# 1978 Corvette: Service Bulletin: Removable Roof Panel Fit

**Subject:** Removable Roof Panel Fit  
**Model and Year:** 1978 Corvette  
**Source:** Chevrolet Dealer Service Technical Bulletin  
**Bulletin No:** 78-T-23  
**Section:** I  
**Date:** April, 1978

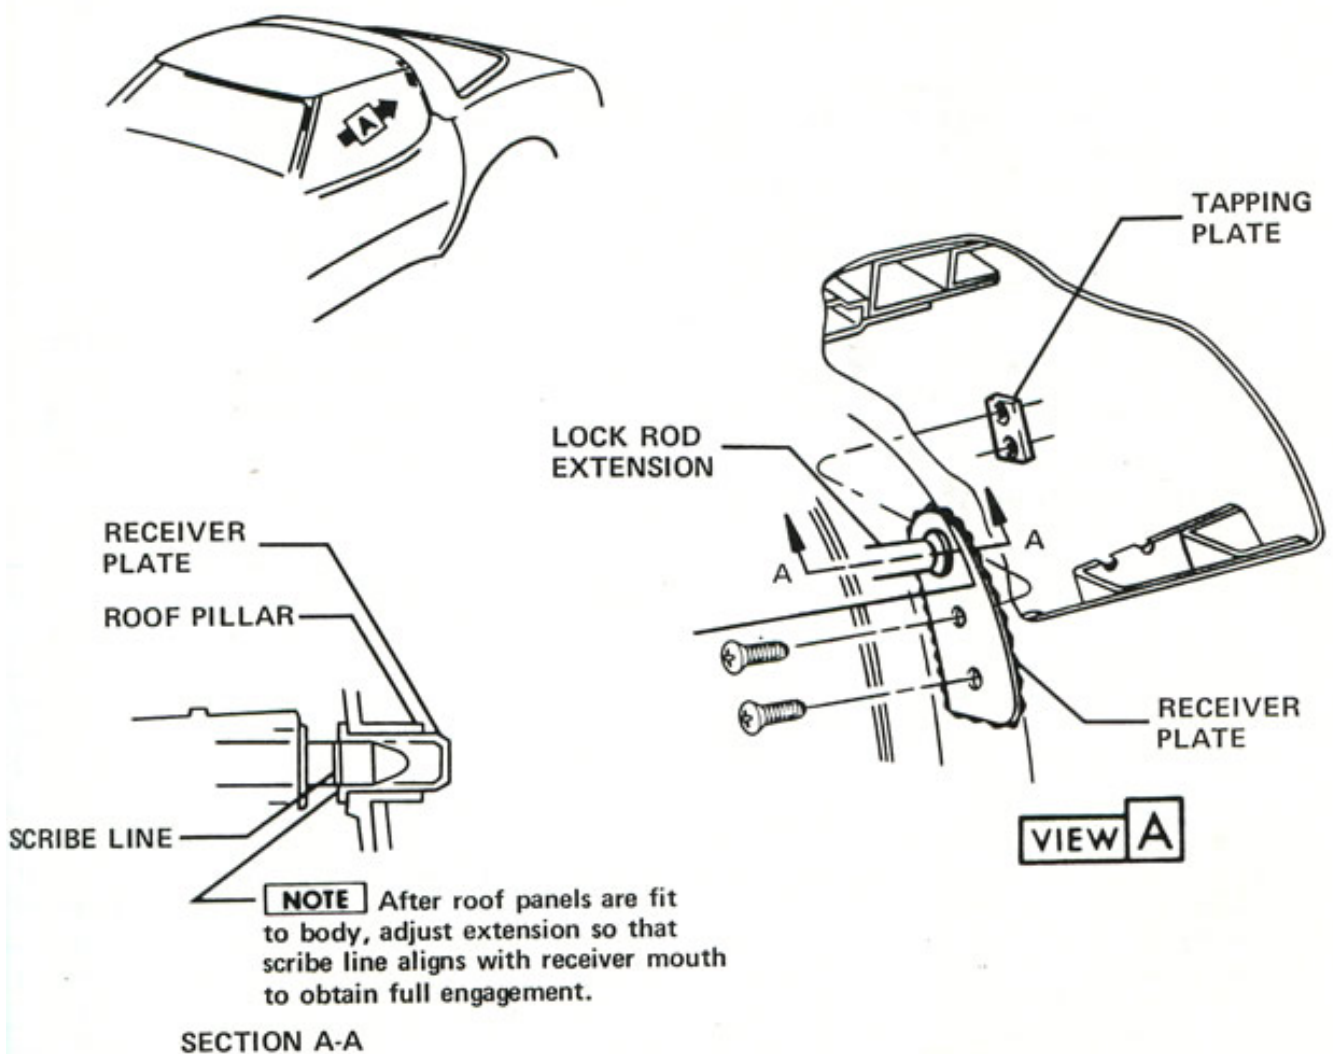
Some early 1978 Corvette removable roof panels may be bowed in relation to the windshield header and/or rear roof. This condition can be caused by an improperly positioned roof lock receiver plate.

The bow in a roof panel can be eliminated by lowering the roof lock receiver plate as outlined below:

1. Remove the rear roof corner garnish and lower roof trim panel.  
NOTE: It is not necessary to remove the shoulder belt or retractor.
2. Remove the roof lock receiver plate screws. Hold the tapping plate, located behind the roof pillar, to prevent it from falling (see illustration on page 2). Remove any excess sealer from pillar and receiver plate.
3. Using a small round file, elongate (lower) the three holes in the roof pillar as required to obtain a relaxed roof panel with a flush fit. This will be a trial and error process of installing the receiver plate and checking that the roof panel lock rod extension engages easily.

4. When an acceptable roof panel fit is achieved, thoroughly pack the area behind the receiver plate with 3M Strip-calk or equivalent.
5. Reinstall interior trim panels.
6. Adjust the door glass to the roof weatherstrip as described in Section 2D, 1978 Service Manual.
